# Pacific Pines Modification Report

An application under Section 75W of the  
Environmental Planning and Assessment Act 1979 to  
modify Ministers Approval MP 07\_0026

Prepared for: The Royal Bank of Scotland  
© GeoLINK, 2012

ILLUSTRATION C2 - GREEN NETWORK PLAN

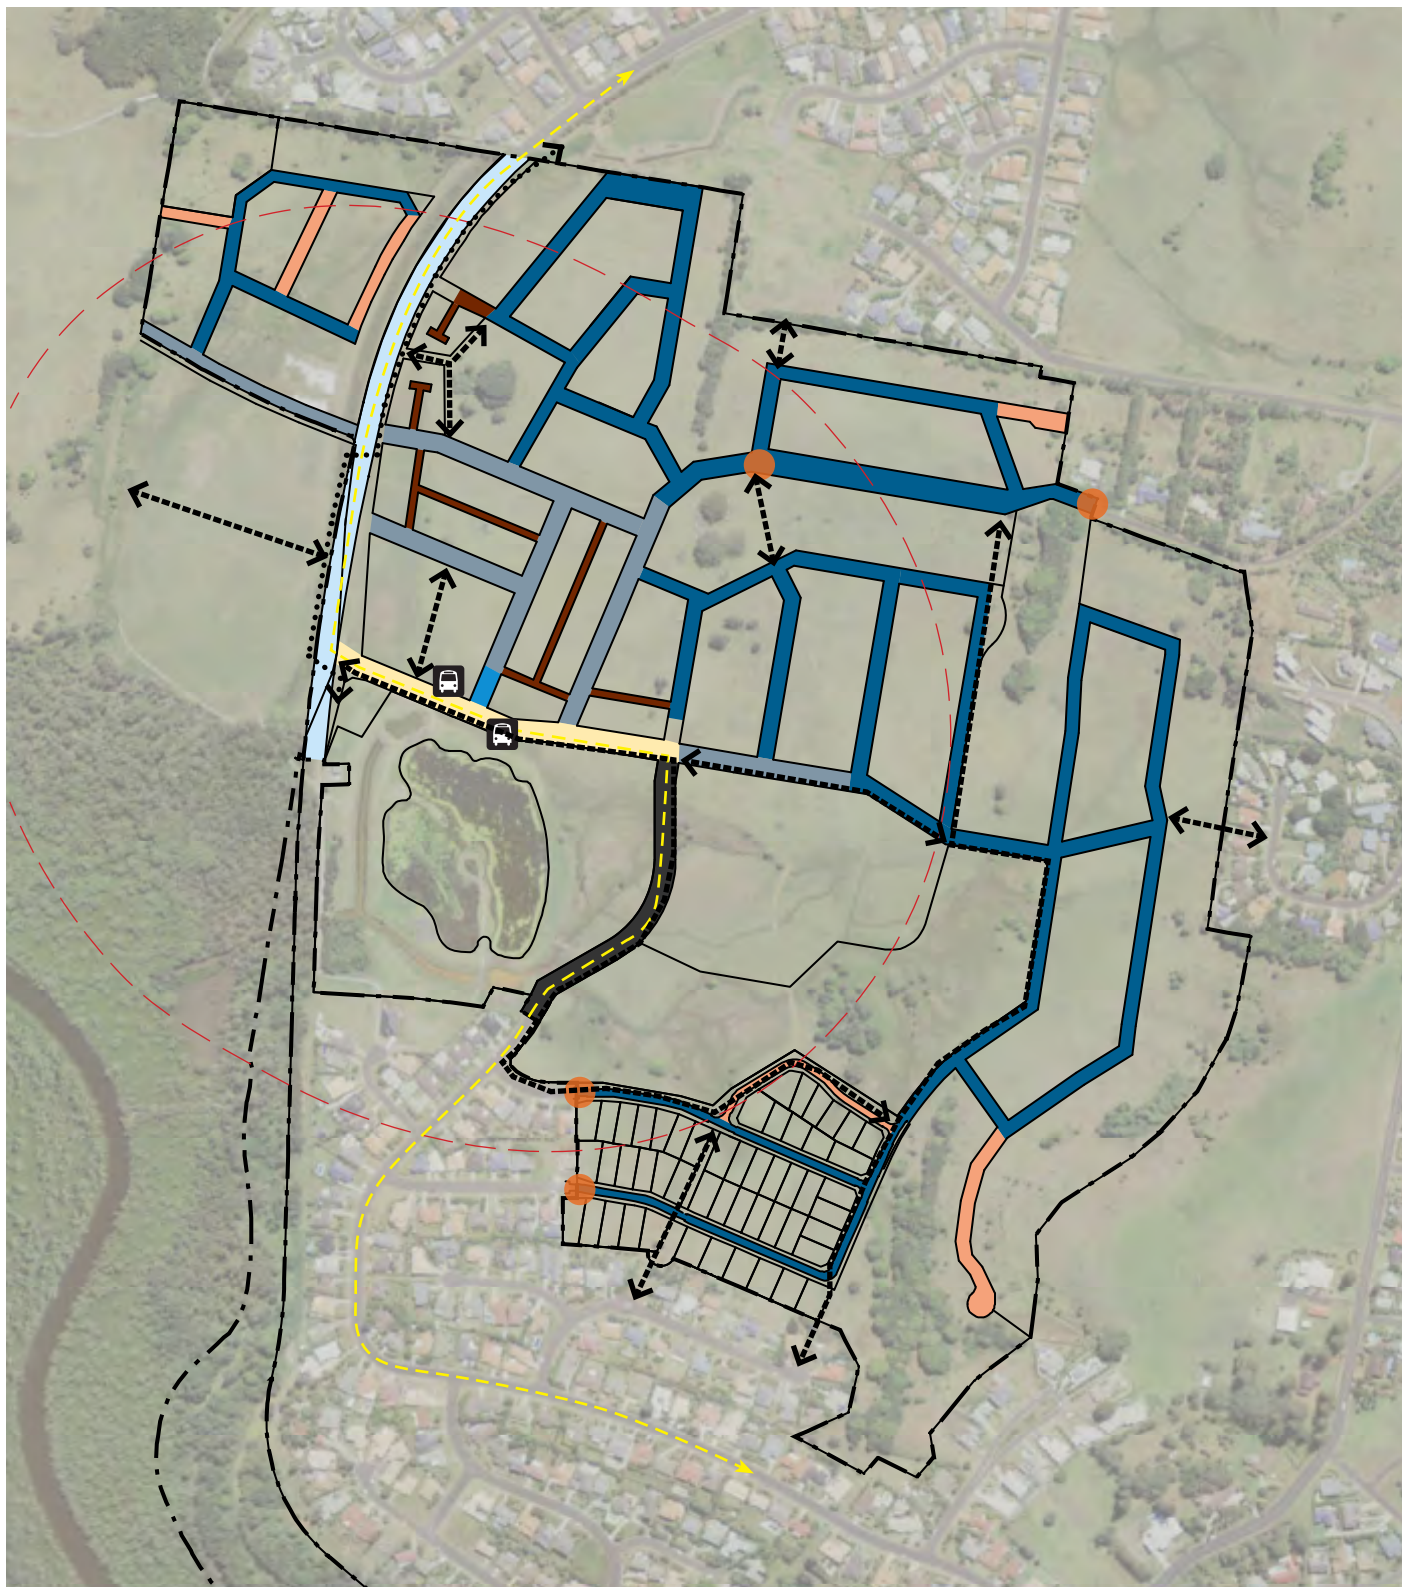
<b>Approved Plan</b>	<b>Update</b>
C1 Concept Plan 100603 1E 16 August 10	C1 Concept Plan 1675144 1F 15 May 2012 <ul style="list-style-type: none"><li>▪ Increased area of Conservation Zone</li><li>▪ Stage 1A lot layout adjusted to meet requirements of condition B10 regarding 20 m buffer to Freshwater Wetlands, as per previous submission dated 16 January 2012</li></ul>
C2 Green Network Plan 100603 6A 11 June 10	C2 Green Network Plan 1675134 6B 17 July 12 <ul style="list-style-type: none"><li>▪ Increased area of Conservation Zone</li><li>▪ Stage 1A lot layout adjusted to meet requirements of Condition B10 regarding 20m buffer to Freshwater Wetlands, as per previous submission dated 16 January 2012</li></ul>
C3 Indicative Neighbourhood Centre Plan 100603 29A 11 June 10	No change – indicative design prepared by consultant no longer involved in the project

ILLUSTRATION C6 - MOVEMENT NETWORK

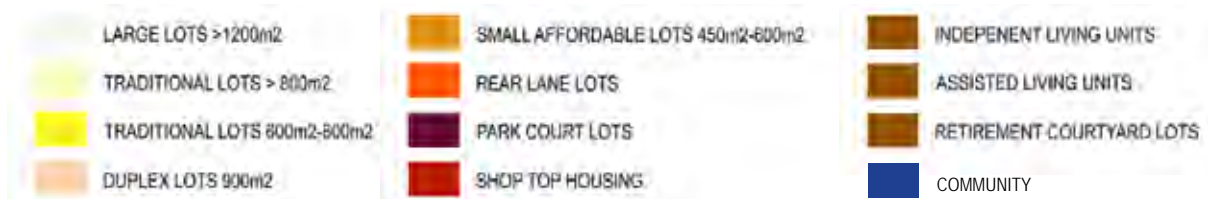
*Illustration C6 Movement Network (as described in correspondence from GeoLINK dated 18 August 2008) is modified such that only two pedestrian linkages are provided within the retained ecological corridor for Freshwater Wetlands EEC as follows:*
